SUBJECT: 25-040 Loaf Land Subdivision - Comment Response

Thank you for your review of the Subdivision Application Permit (SP 4103) for Loaf Land Subdivision in Coplin Plt.. The team recently received review comments from LUPC in regard to this application, dated July 1, 2026. These comments can be seen below in *italic*, followed by Main-Land's response in regular typeset. For the reviewer's ease, we have provided a new printed and PDF copy of the application with the additional and/or updated materials associated with this submission.

FILTER POND
PLAN & PROFILES

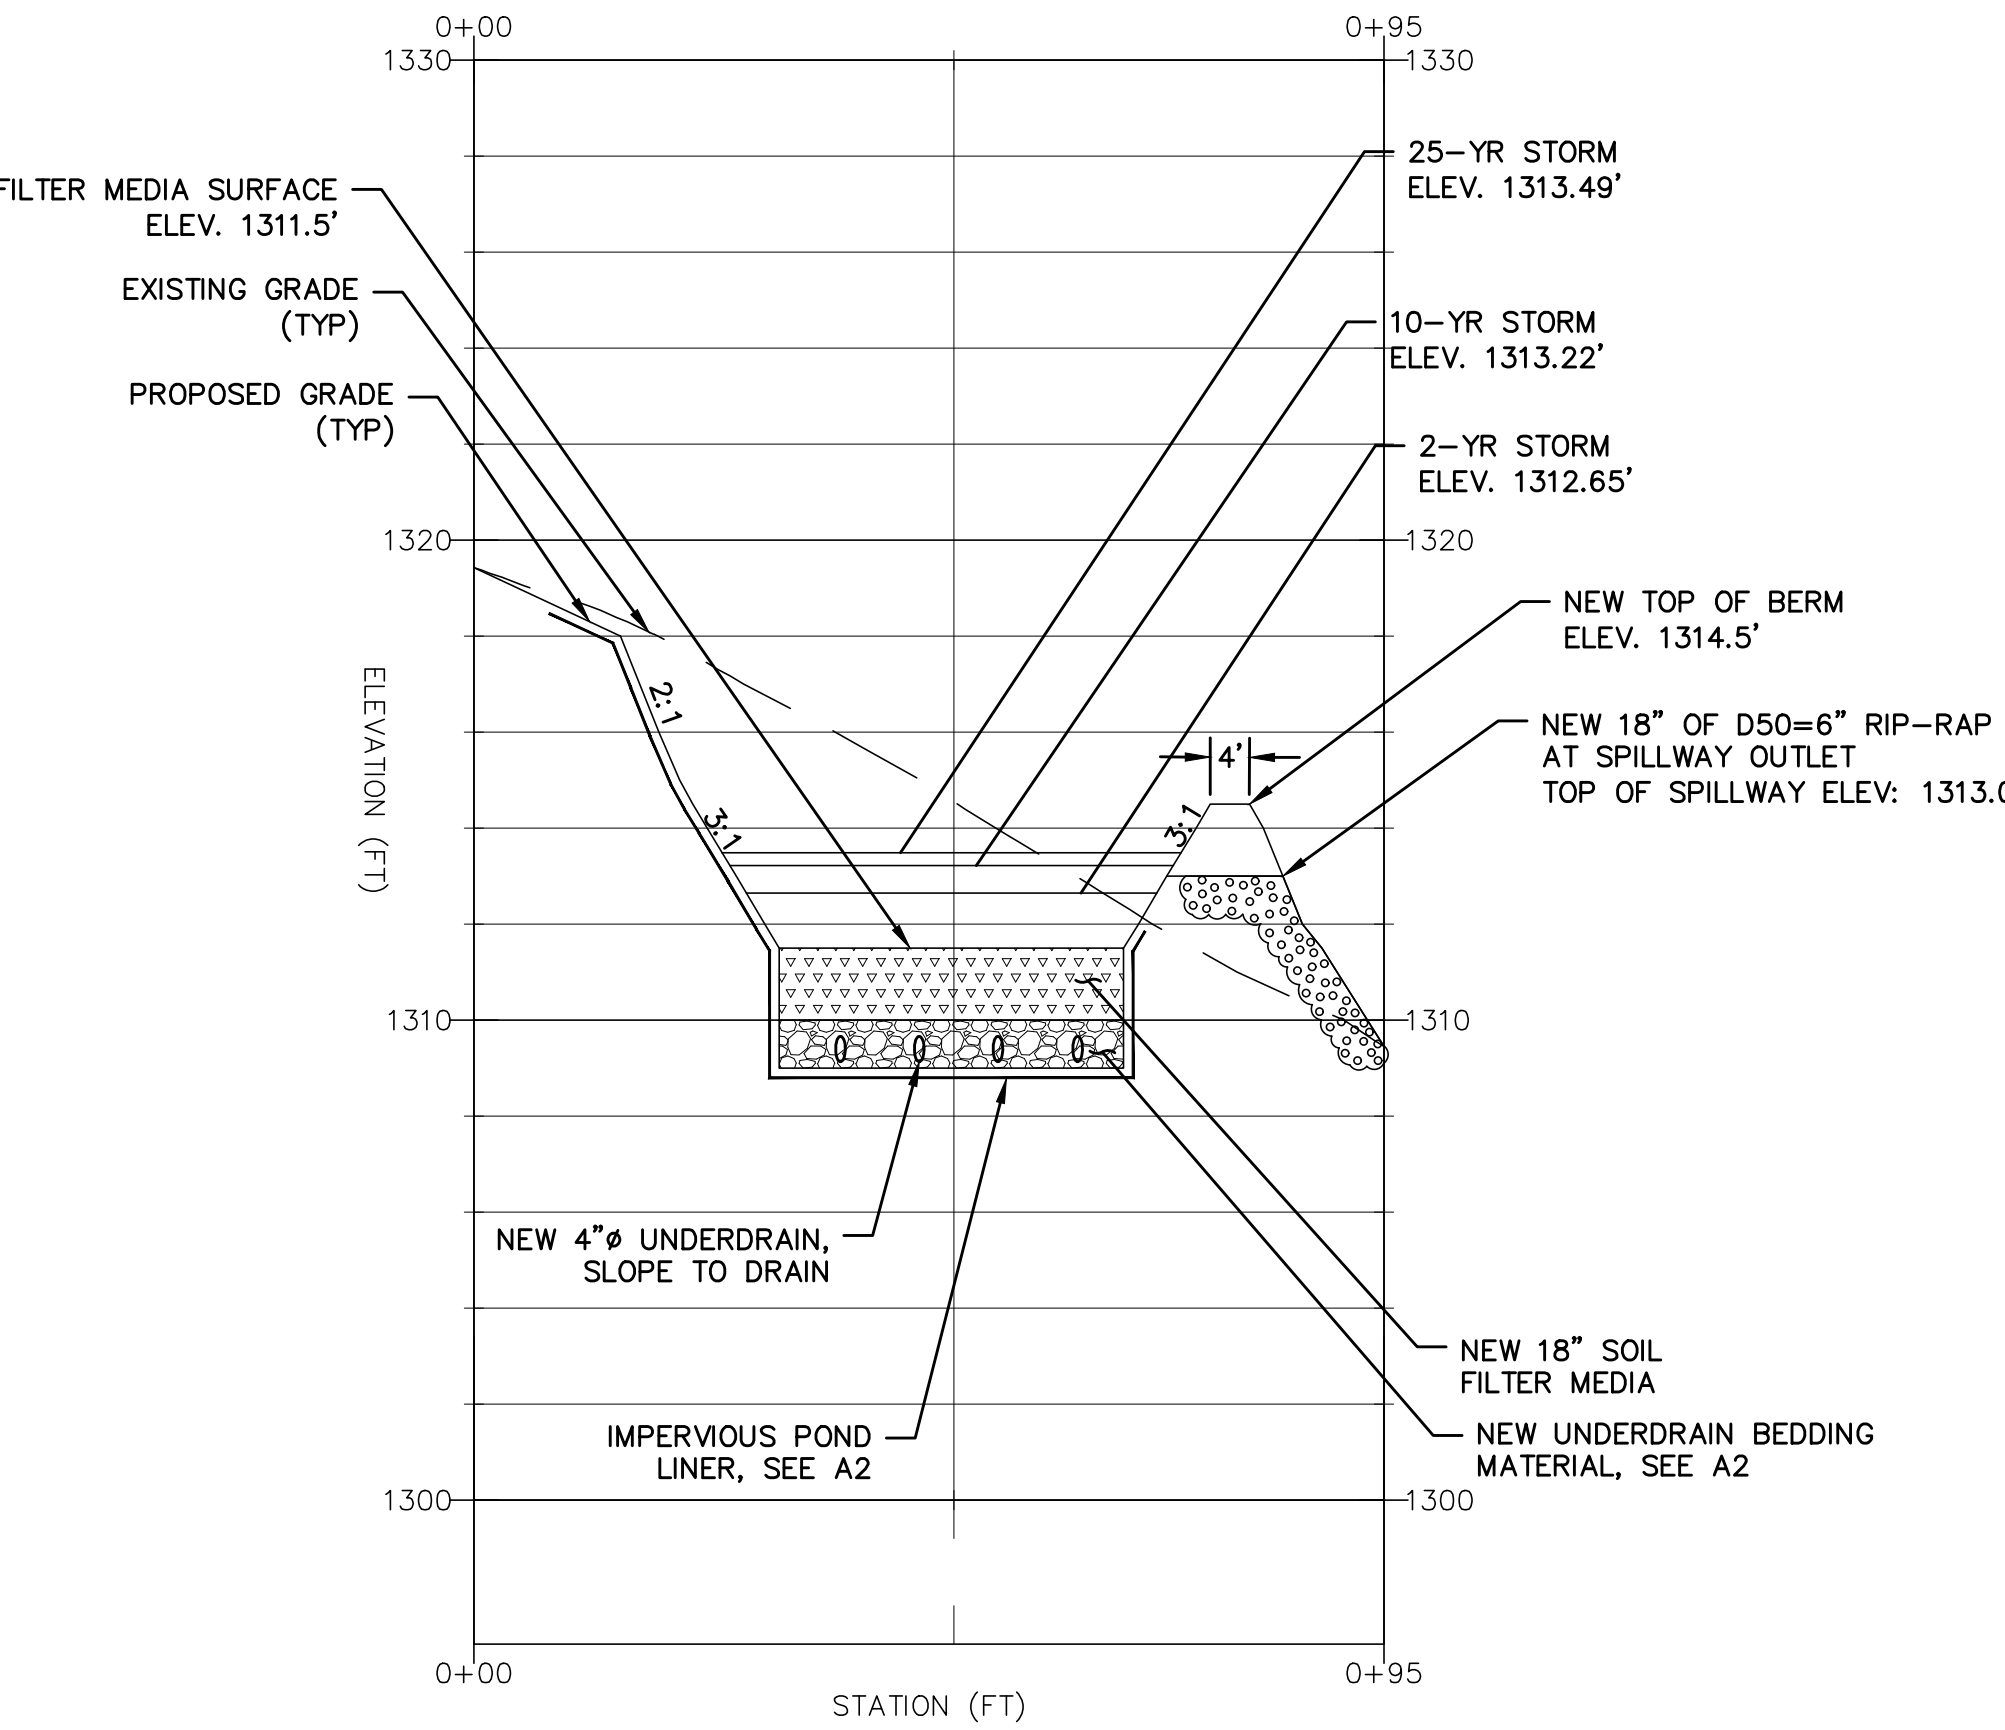
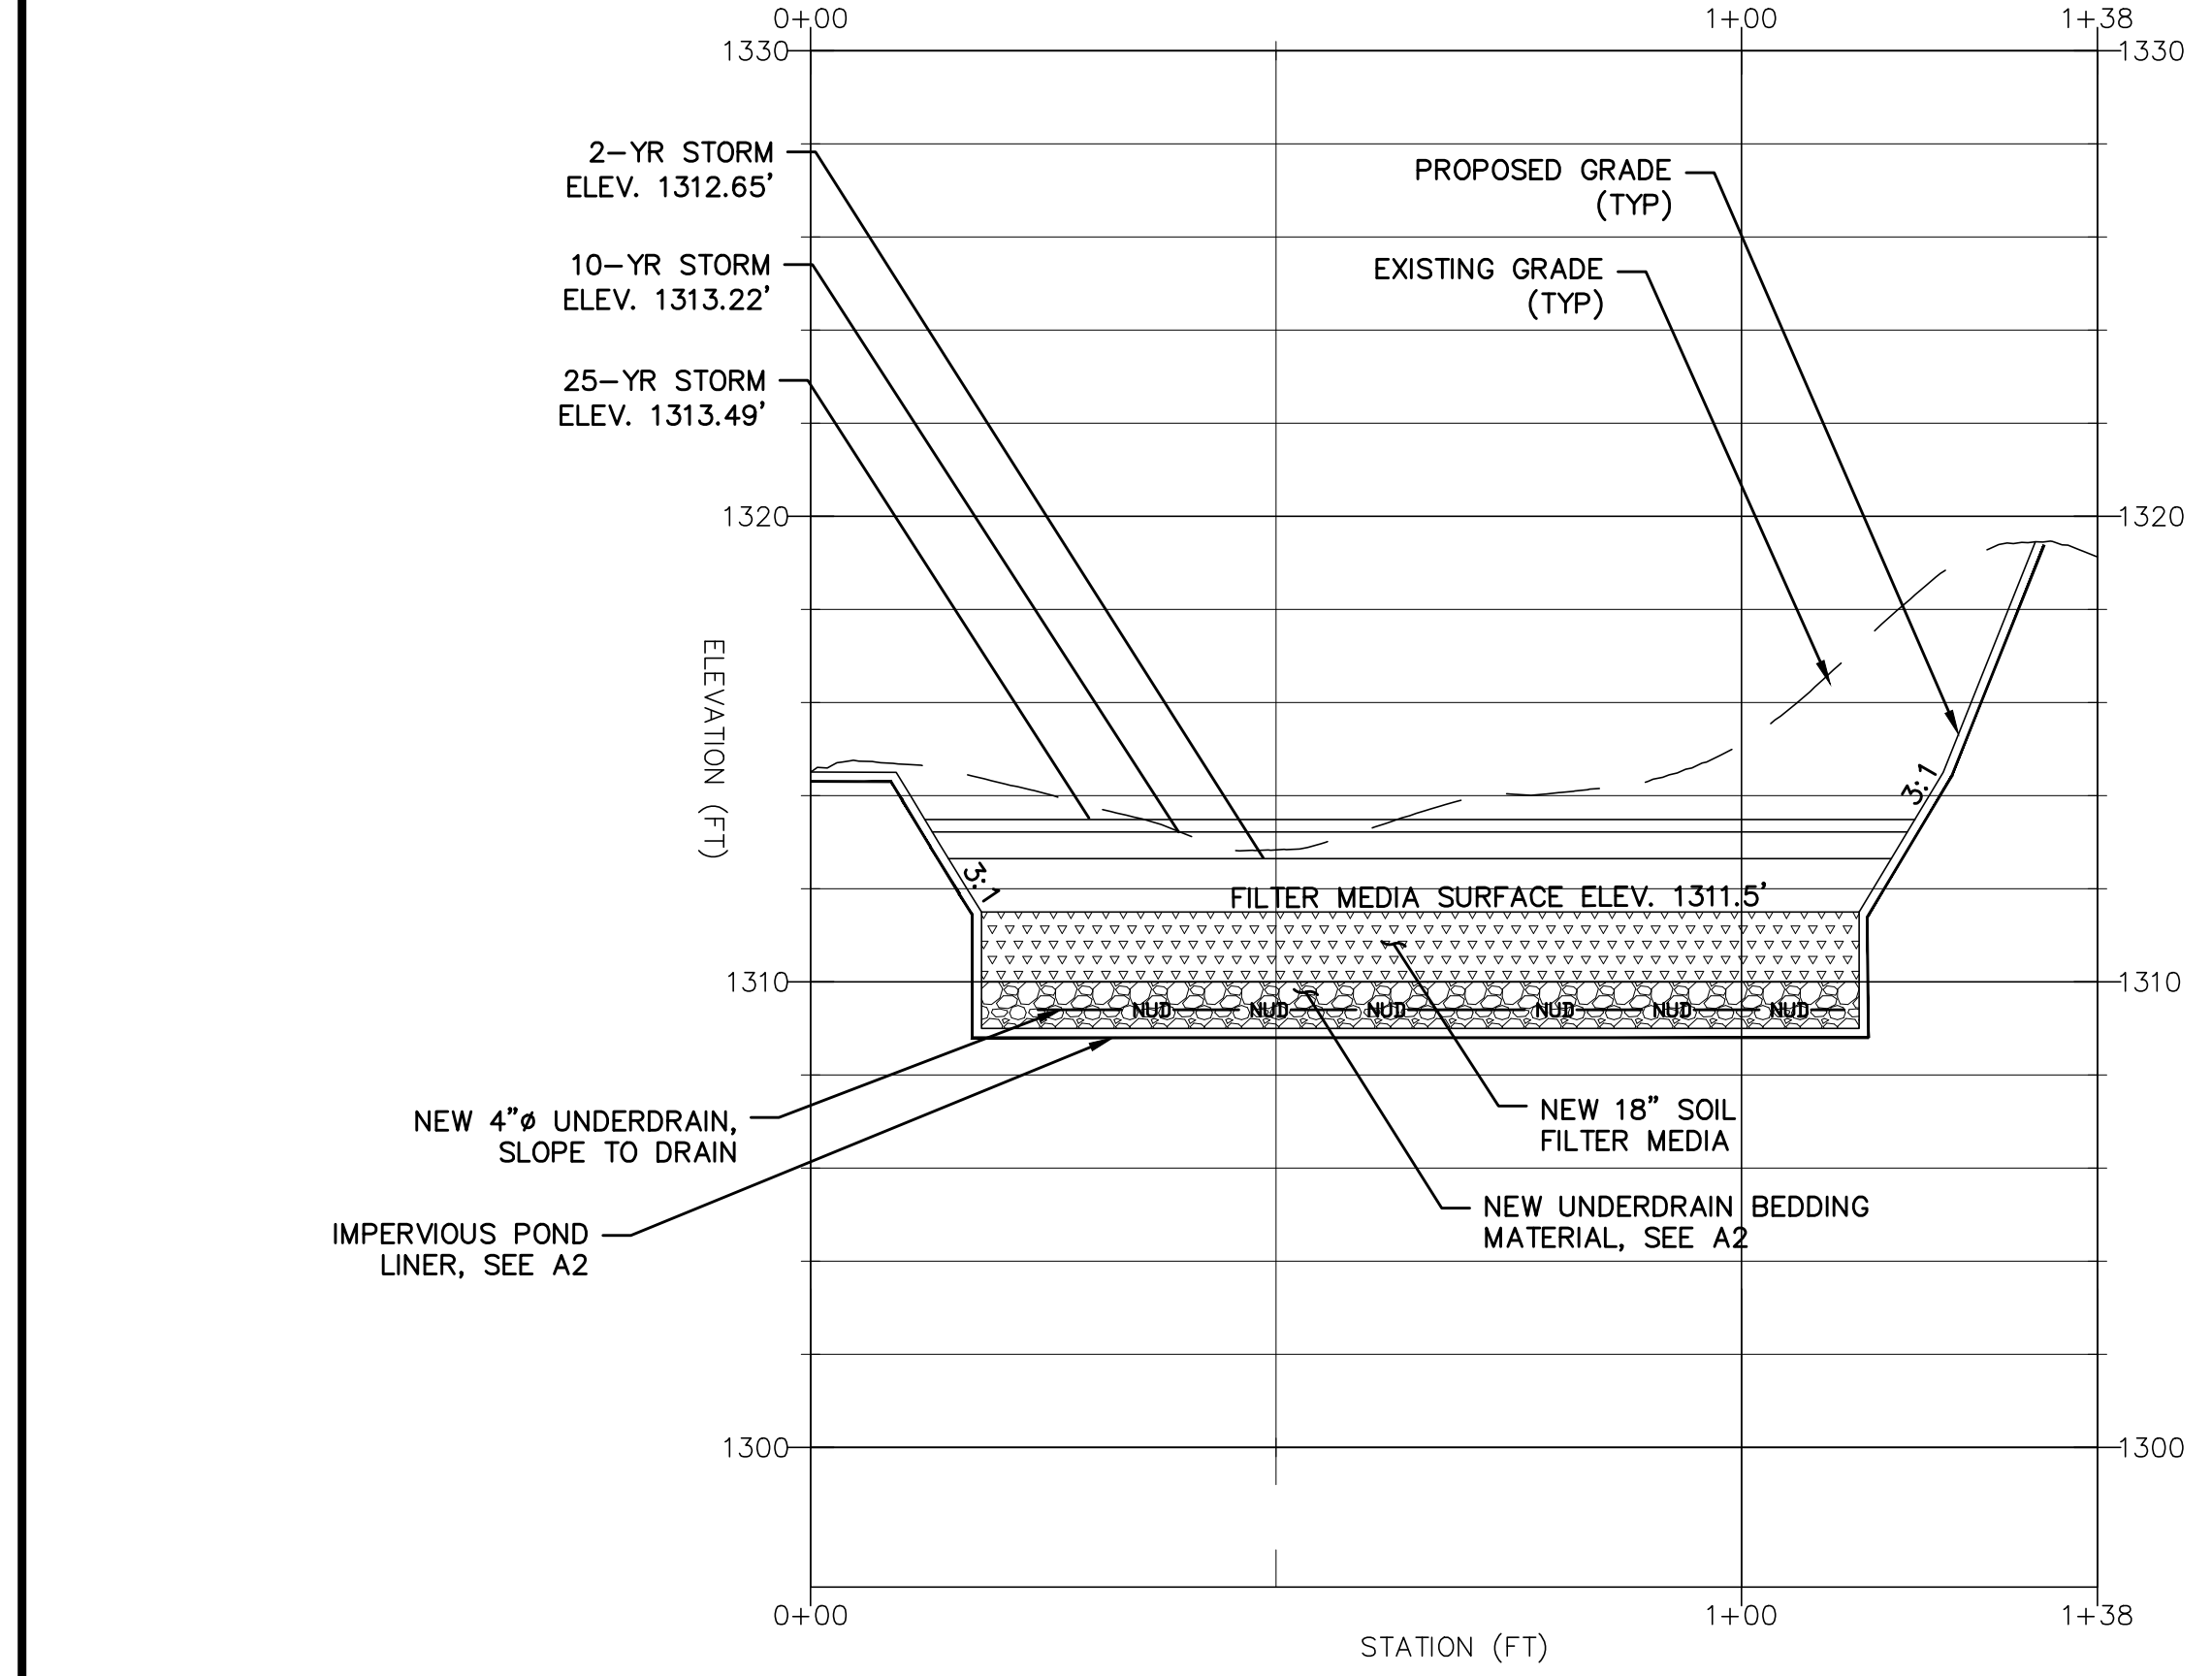
o *Sheet C6.2 – Filter Pond 2 Plan and Profiles*

▪ *Address comment IV.5 in the review by Sebago Technics*

IV. 5. The plan for Filter Pond 2 indicates the need for an uphill retaining wall or a boulder wall. The design team should provide details of the proposed retaining wall.

Since the treatment factor for Filter Pond 2 has been set to 0.25, the pond size was able to be slightly reduced. Because of this, the need for a retaining/boulder wall has been eliminated. This update is reflected in the revised plan set.
